## Rezoning Transportation Analysis

Petition Number: 2019-114

Revision Log:	Date	Description
	09-19-19	First Review

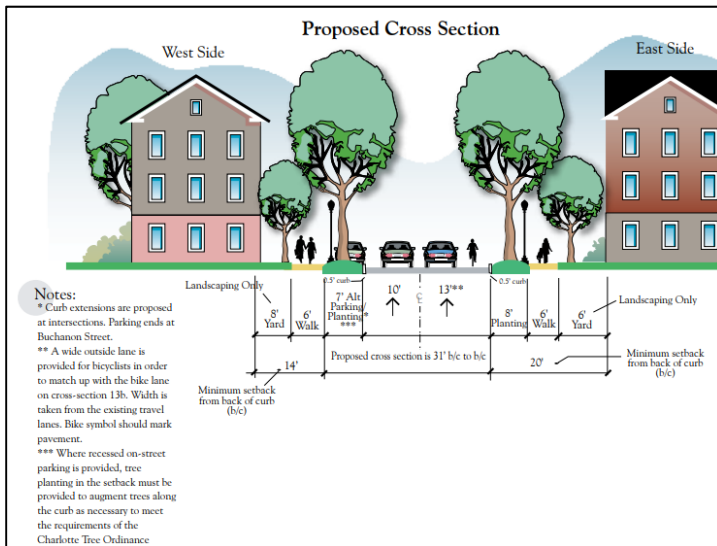
- The petitioner should revise the site plan and conditional note(s) to eliminate conditional note(s) 7a and 2a. The streetscape in accordance to the Dilworth Land Use and Streetscape Plan (see illustration below) to construct an 8-foot planting strip, and 6-foot on Scott Avenue between Fillmore Avenue to Pierce Street. The site plan should label and dimension both items from the back of curb and gutter and road centerline.

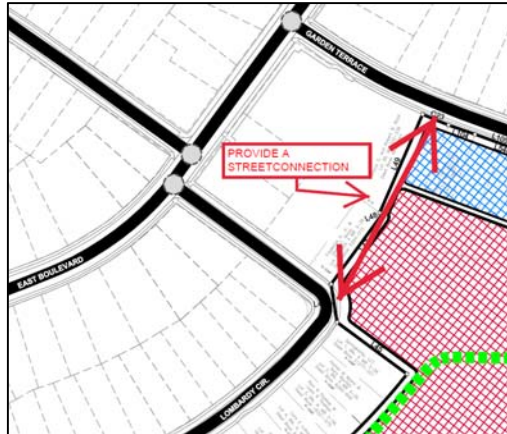
10. The petitioner should revise the site plan to commit to construct the extension of Lombardy Circle to Garden Terrace (see exhibit below). The street can be a public street or private street. If it is going to be a private street, then it should provide a public access easement.

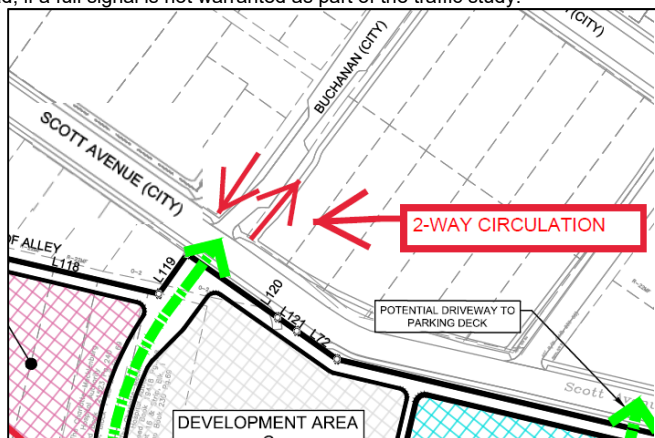
14. The petitioner should revise the site plan and conditional note 5E to abandon a smaller portion of Fountain View Street up to the new internal street intersection (see exhibit below).
